Proposal for amendment to global technical regulation No.13 (Hydrogen and fuel cell vehicles)

This document is prepared in order to help reviewing the proposal for amendment to global technical regulation No.13 (Hydrogen and fuel cell vehicles) submitted the European Commission (informal document GRSP-54-11) by indicating the changes from the global technical regulation No.13 (ECE/TRANS/180/Add.13) by bold or strikethrough characters.

Figure 3
Verification test for expected on-road performance (pneumatic/hydraulic)

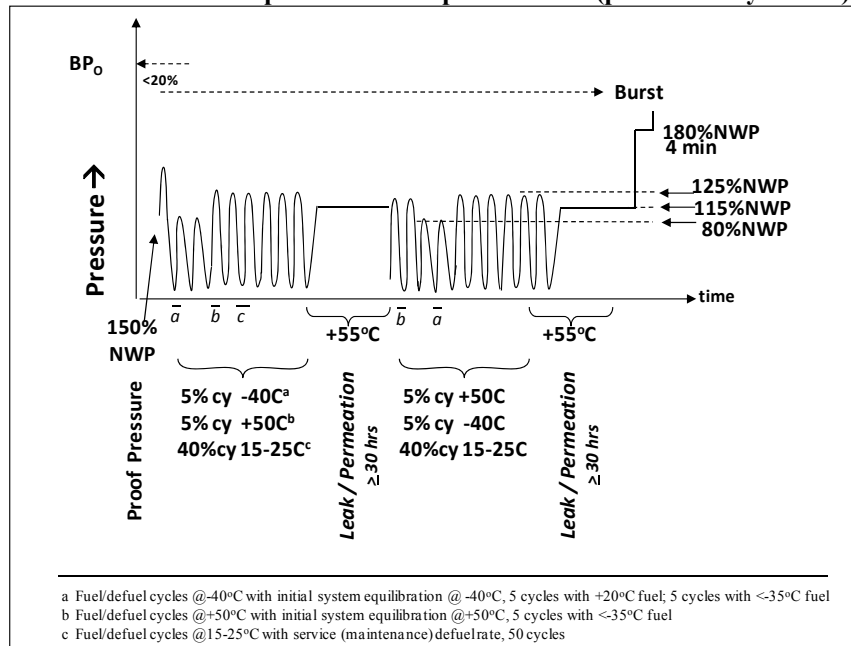
A system is pressurized to 150 per cent NWP (+2/-0 MPa) for **at least 30 seconds** (para. 6.2.3.1. test procedure). A storage container that has undergone a proof pressure test in manufacture **ismay be exempted** from this test.

The storage container undergoes a hydraulic burst to verify that the burst pressure is ~~within 20~~ **at least 80** per cent of the baseline burst pressure determined in para. 5.1.1.1. (para. 6.2.2.1. test procedure).
